PUBLIC COMMENT SHEET

Your suggestions and comments are important to the US Highway 16 Neighborhood Area Future Land Use planning process. Please feel free to provide any comments you wish to make regarding the Plan. Please hand in this sheet before you leave the open house or send written comments by September 30, 2004 to: Patsy Horton, Rapid City Growth Management Department, 300 Sixth Street, Rapid City, SD 57701. Thank you for your help.

US Highway 16 Corridor Study Future Land Use Map

RE: Postponed Public Meeting, October 14, 2004
Public Meeting, 8/12/04 – Future Land Use Plan – 2004; US 16 Corridor Study: Schmid
/ Shultz 5 parcels, Catron Boulevard and US Highway 16

PROPOSED REALIGNMENT OF SAMMIS TRAIL

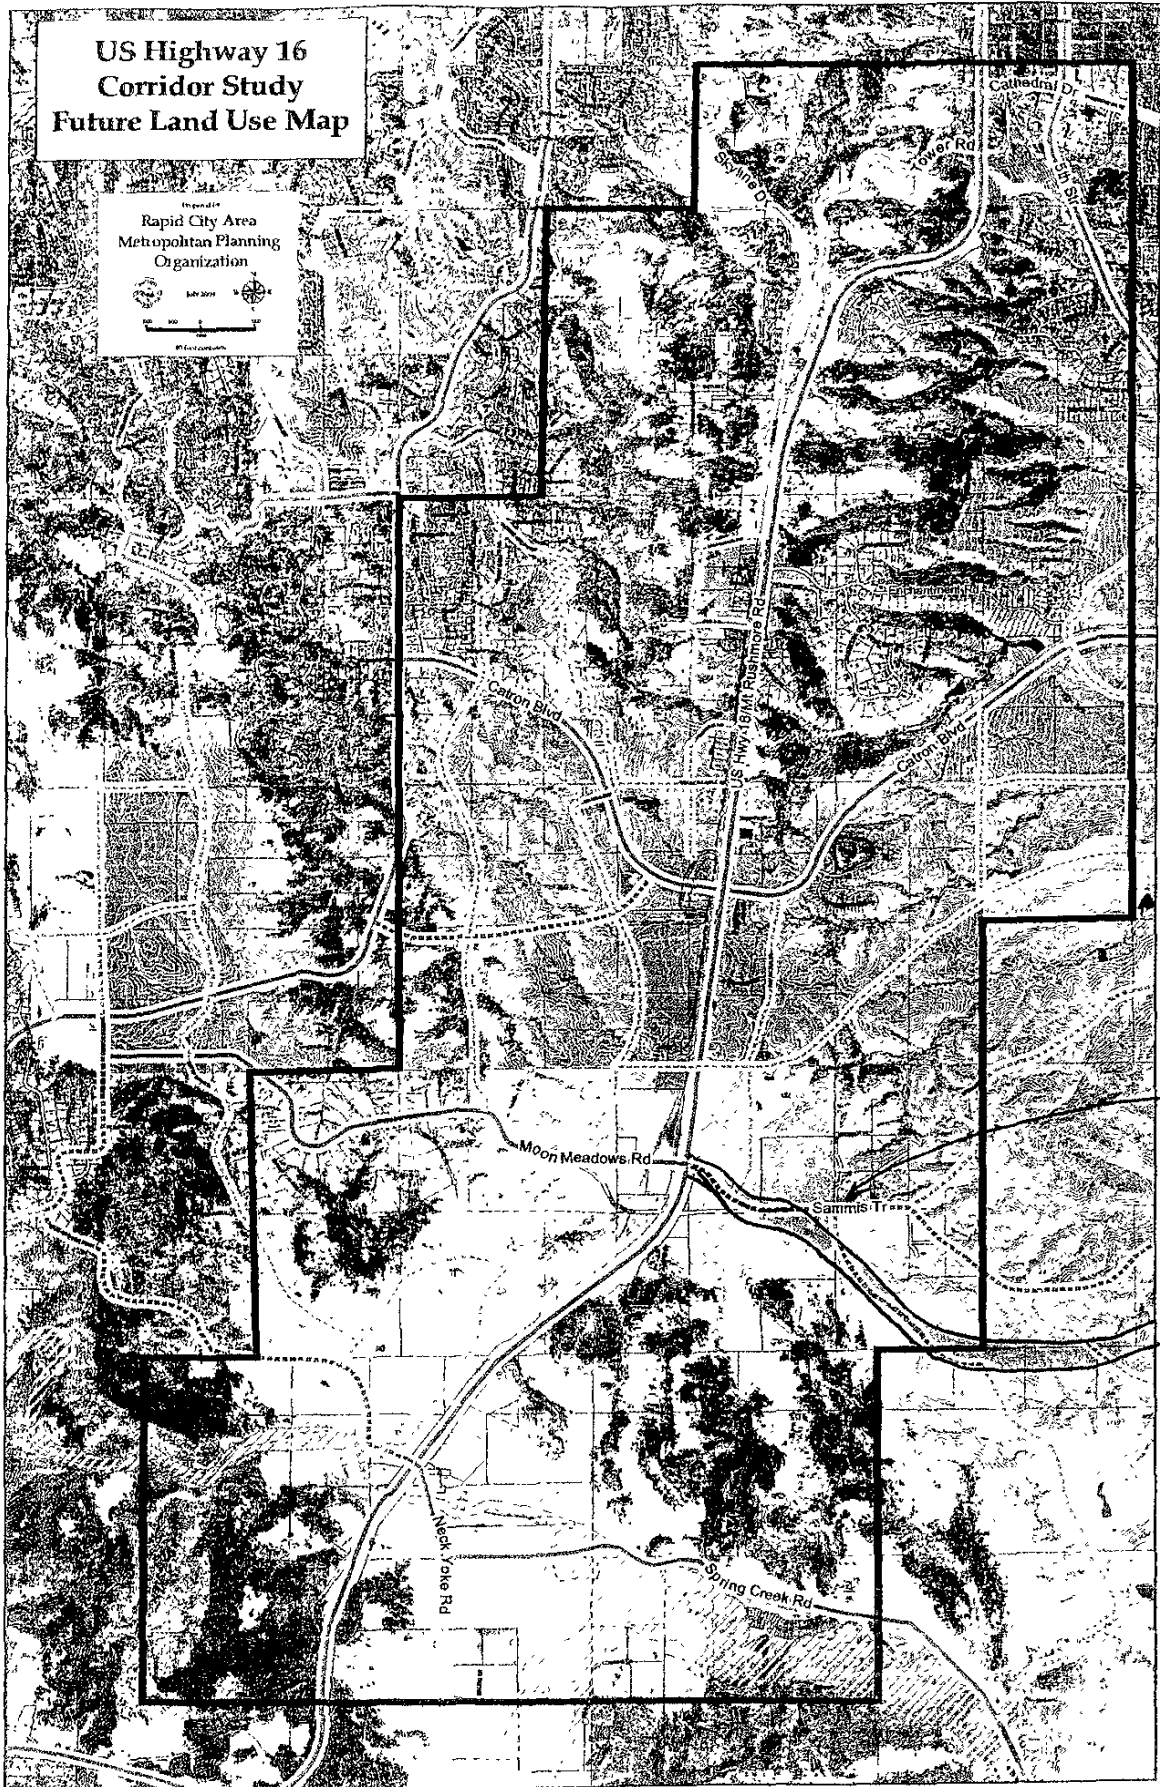
- C. There is undeveloped land that can be used to correct problems with the Right of Way for Sammis Trail and the 90° intersection of the Spring Creek connector at the Hyland Park proposed development. This 90° intersection is a very difficult transition for this traffic onto Sammis Trail, especially when at peak hours there could be the possibility of 3,000 cars per hour!

We suggest that this road go from Sammis Trail at a smooth angle through the proposed development at its West boundary to the section line/base line at the south end. This will provide better access to the property east, eliminate the 90° intersection, and avoid property disputes in the future. (See our map of proposed traffic changes given to Marcia Elkins.)

*Eliminate
the 90°
Intersections*
